From: [REDACTED]
To: [Luton Airport](#)
Subject: The expansion plans for London Luton Airport
Date: 30 August 2024 16:15:26
Attachments: [RELAS AD6 Stage 7 Common Submission version 1.0 compressed \(1\).pdf](#)

RELAS AD6 Stage 7 Common Submission

Version 1.0 - 27 August 2024

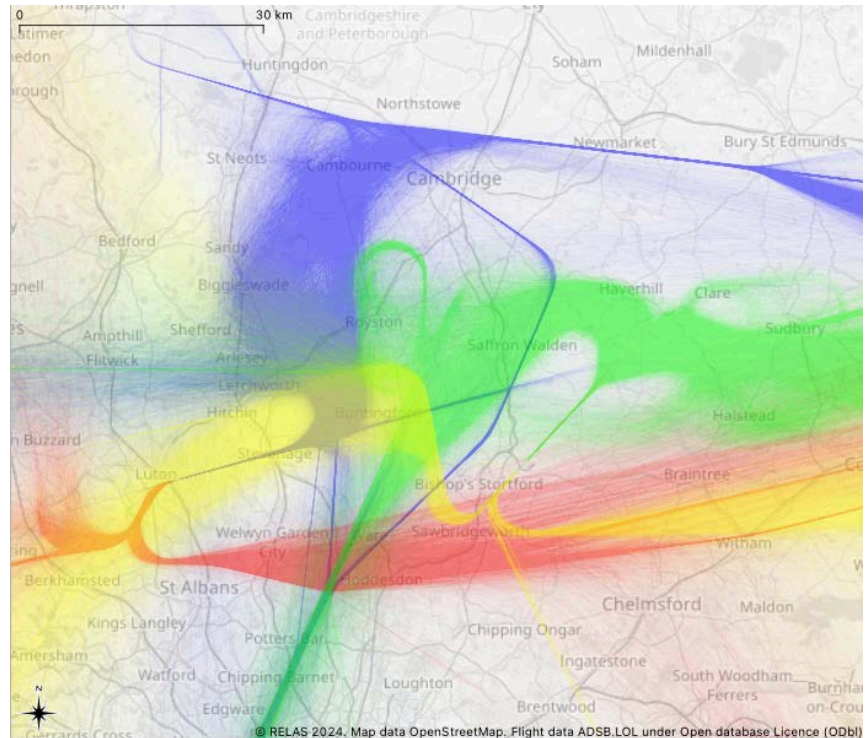
The restriction on Luton only operating CDO below 5,000ft rather than from top of descent due to airspace conflicts is no longer valid, especially for aircraft arriving from the east.

This restriction on CDO only being in operation below 5,000 ft should be removed⁵. Aircraft arriving at Luton should be required to fly CDO from ToD, and report CDO on at least the same basis as other London airports.

No explanation has ever been given why the Luton arrivals marked in blue can not operate CDO from ToD, especially early in the morning (e.g. 6:30 to 8am overflight of West Cambridge).

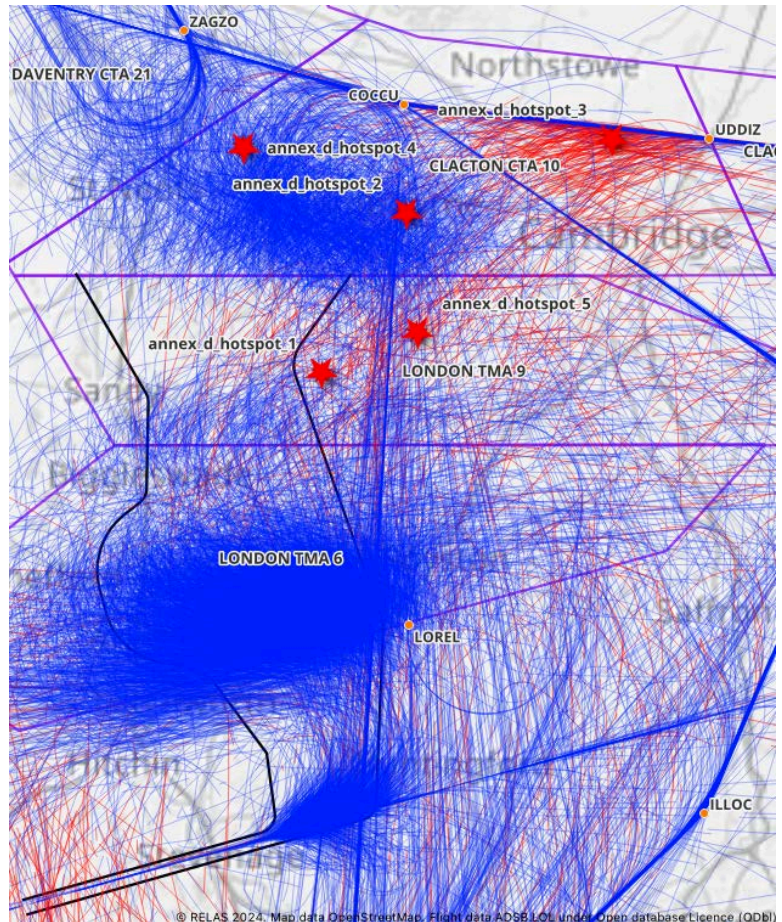
Ideally, aircraft should descend smoothly at a 3-degree angle (CDO). However, the chart reveals stepped descents with steep drops (red lines show >2500 ft/min, ~5.6degrees) and long level flight periods (blue lines show <250 ft/min). Complaint hotspots are shown by red stars.

Stepped descents cause increased noise due to increased engine thrust and abnormal recognisable and intrusive pitch patterns. This approach is less efficient in terms of CO2 emissions and noise reduction.

A significant portion of these flights are in peak periods (06:45 to 8:00 am), even when there's little conflicting air traffic which might justify this non-optimal approach. A contributing factor is the sudden change in minimum height from 11,000ft to 8,000ft after UDDIZ, as aircraft attempt to shortcut across CLACTON CTA 10 airspace.

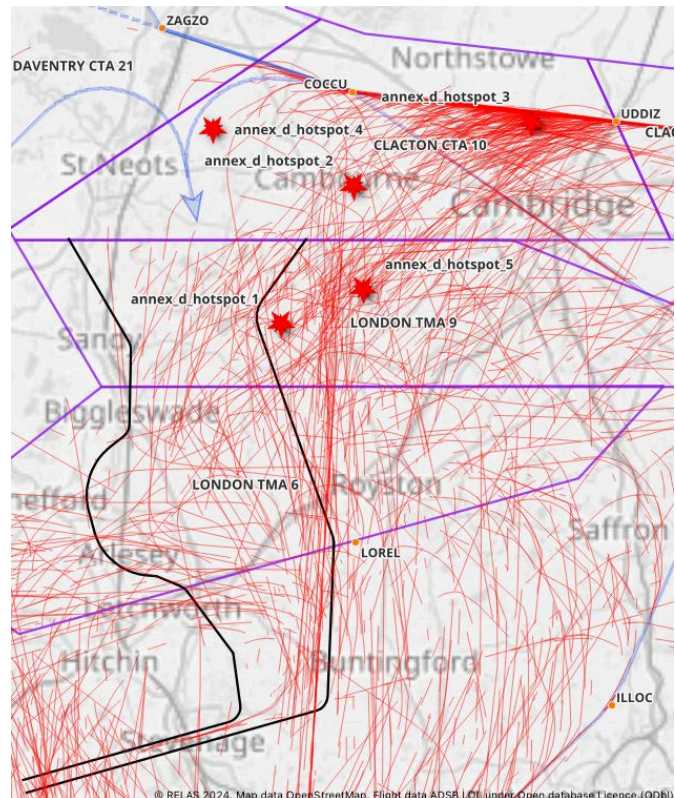
As above, airspaces are outlined in purple, and red stars show complaint hotspots. Red lines show steep descents.

As discussed earlier [5.1.3], for around 90% of the aircraft landing at Luton, descent rates greater than 2000 ft/min require speed-brakes (or lowered undercarriage) to maintain a constant speed of 250 kt or less.

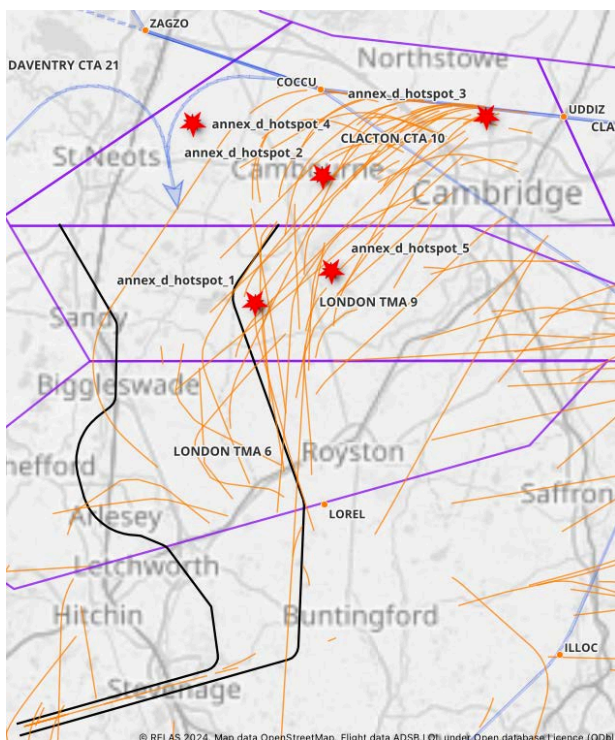
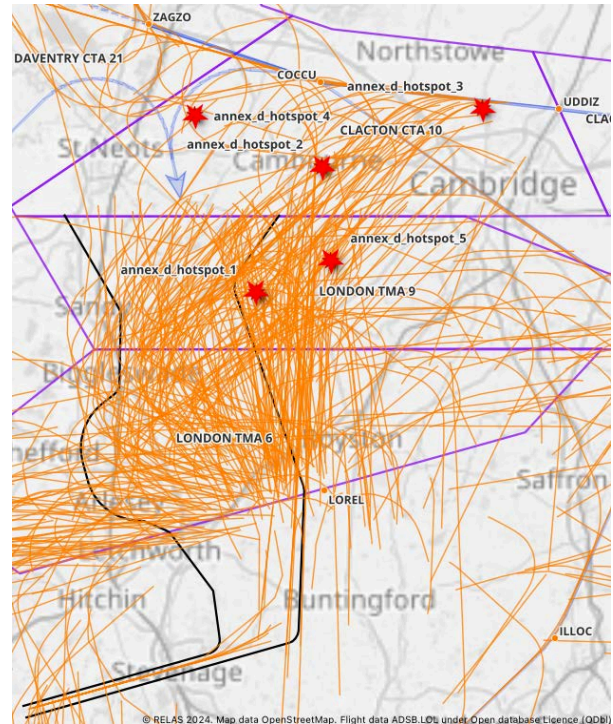
These overspeed areas highly correlate with complaint hotspots. The excuse of urgent arrivals is invalid, as there are looped overspeeds and overspeeds in the hold.

Many overspeeds occur late in the approach..

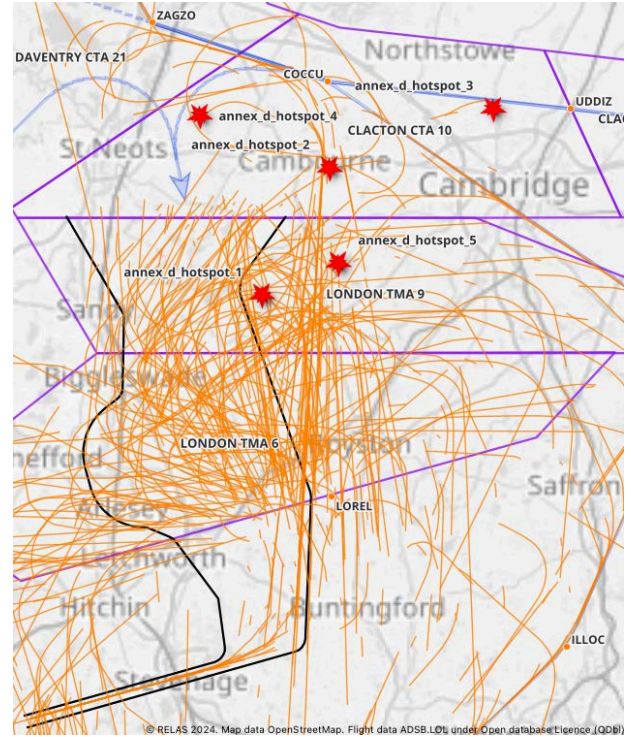
The 180-degree turn over Hotspot 2 may also be executed at significant speed, typically above FL100.

Some flights from the South loop around hotspot 1, then head South on a downwind leg toward Luton's runway centreline, all at over 250 kt.

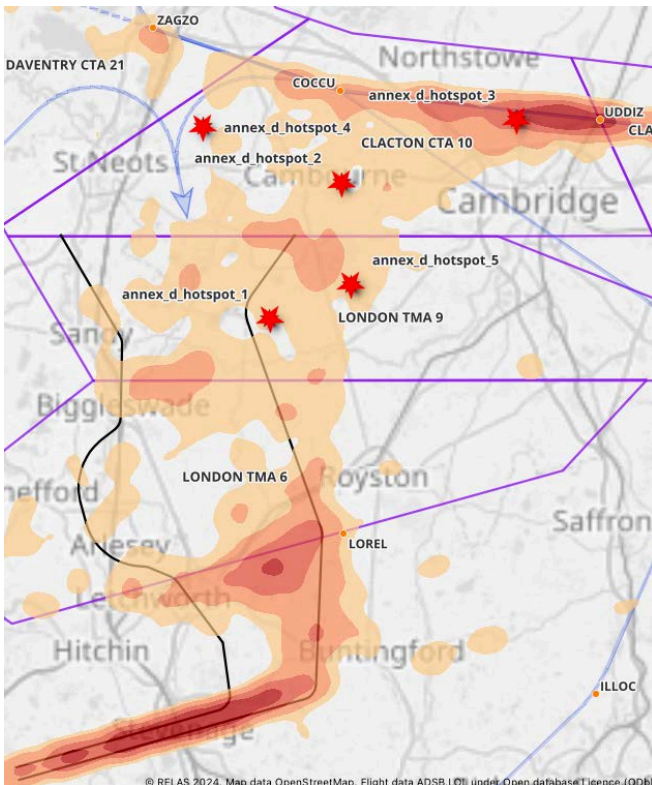
Darker colour of orange/red indicates a larger count of aircraft have changed the height requirement on the aircraft's Flight Management System.

Note the correlation with complaint hotspots, as indicated by red stars.

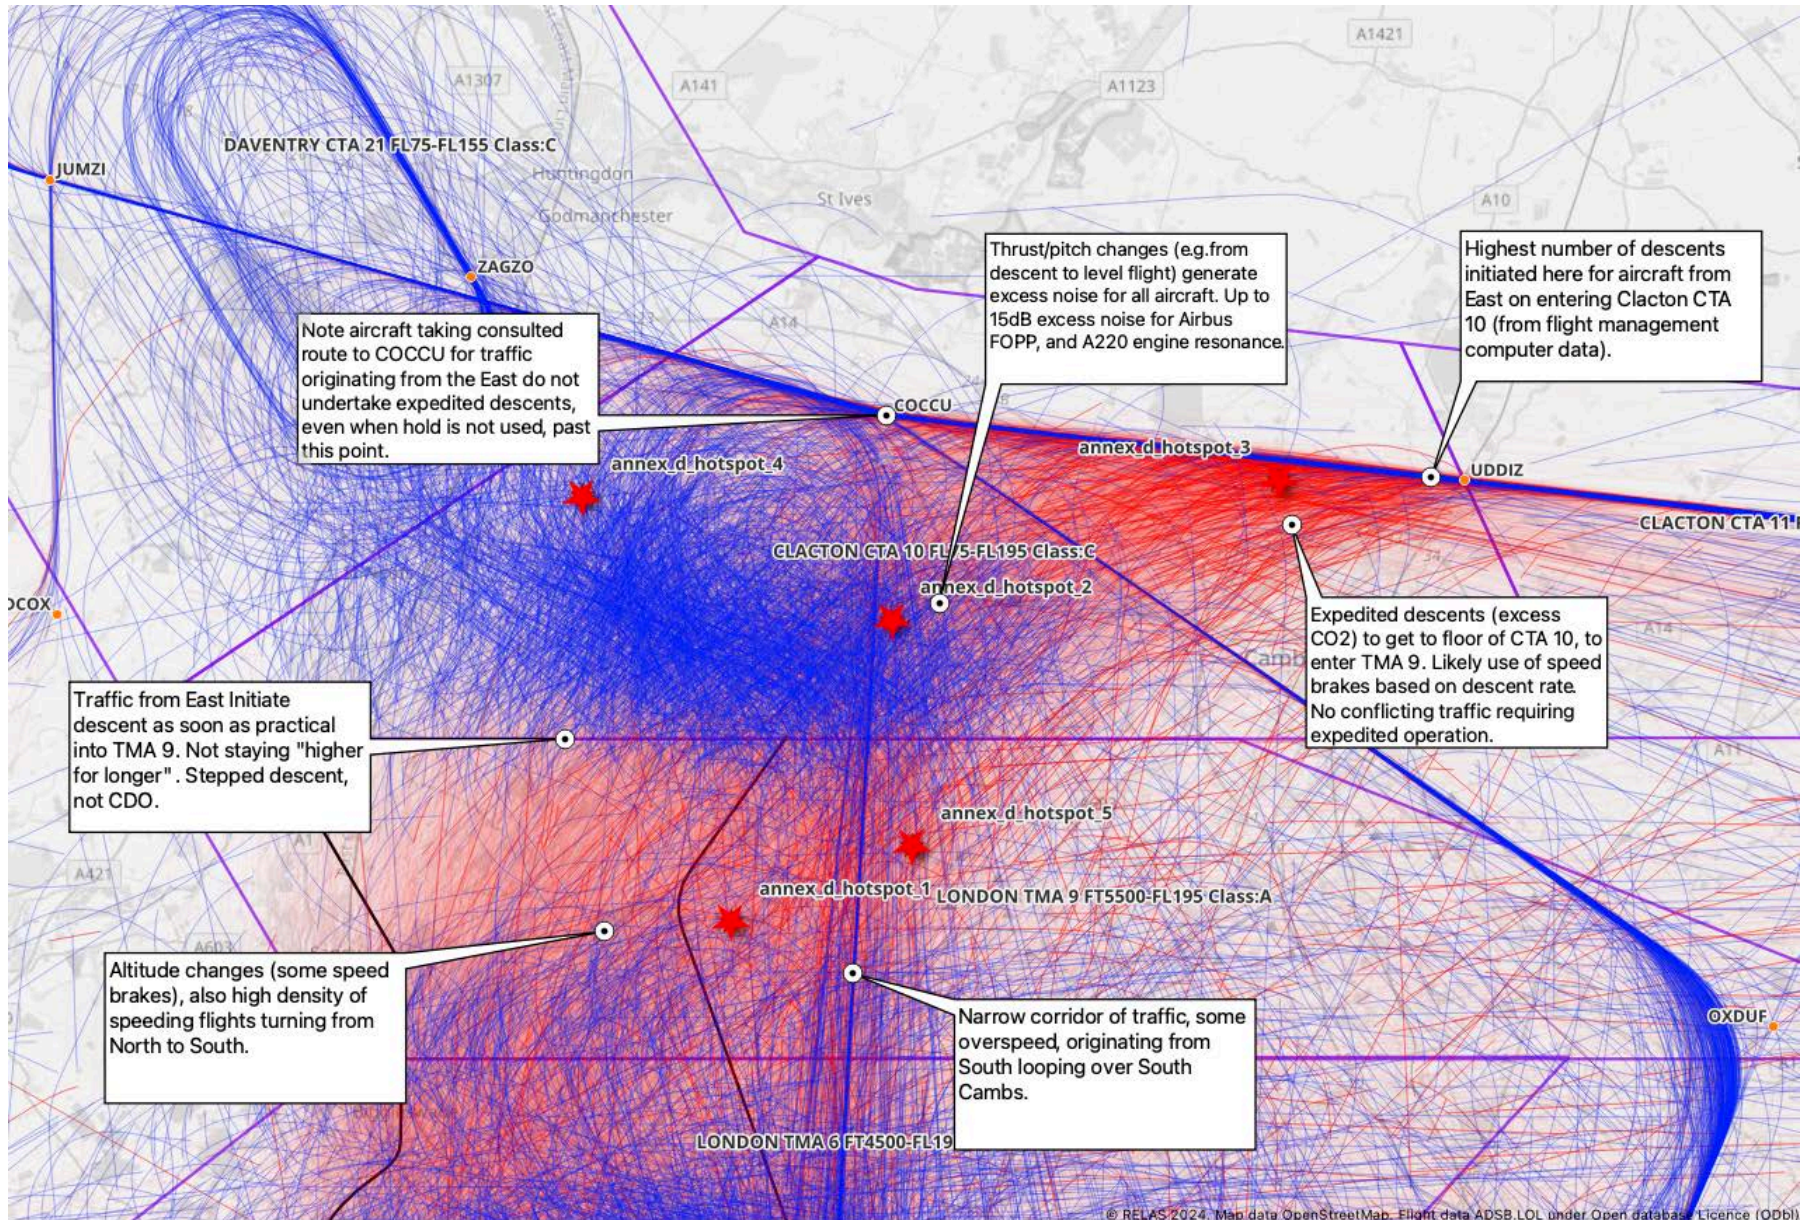
A combination of all the factors and events described in Section 6 is accumulated in the diagram below. It shows a series of hot spots and events that cause extra noise and disturbance to the residents under the flightpath. Again, red tracks show steep descents, blue lines show level flight.

Figure 11 Option 1 for Westerly Runway 25 – Vectoring and Shortcuts

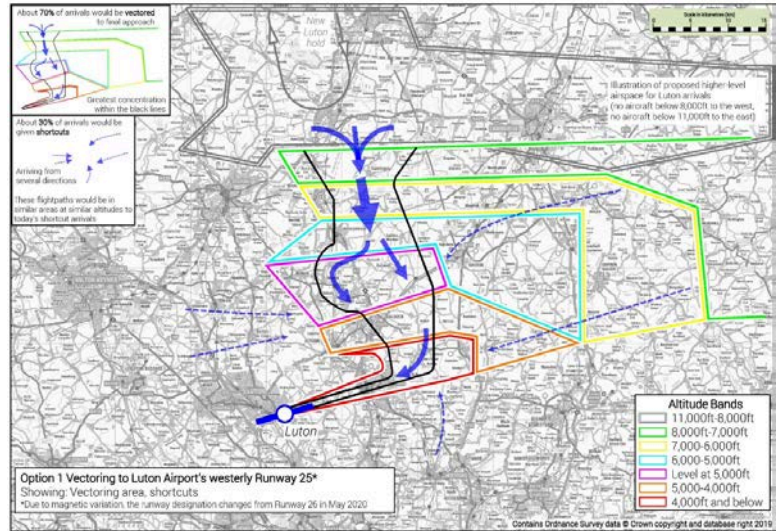
The key on the consultation diagram (reproduced on the right) states 'Altitude', i.e. feet above sea level.

However, Luton has rejected most complaints about height relating to coloured bands above 5,000 ft with reasons including:

2. Lack of clarity whether the on the consultation diagram should be interpreted as flight levels or altitudes.
3. Leveraging the fact that the Luton Travis noise reporting system labels all aircraft as having a non-specific 'height', and adding un-verifiable height calculations in written responses. Luton refuses to accept complaints from 3rd party systems that might provide both flight level and altitude.
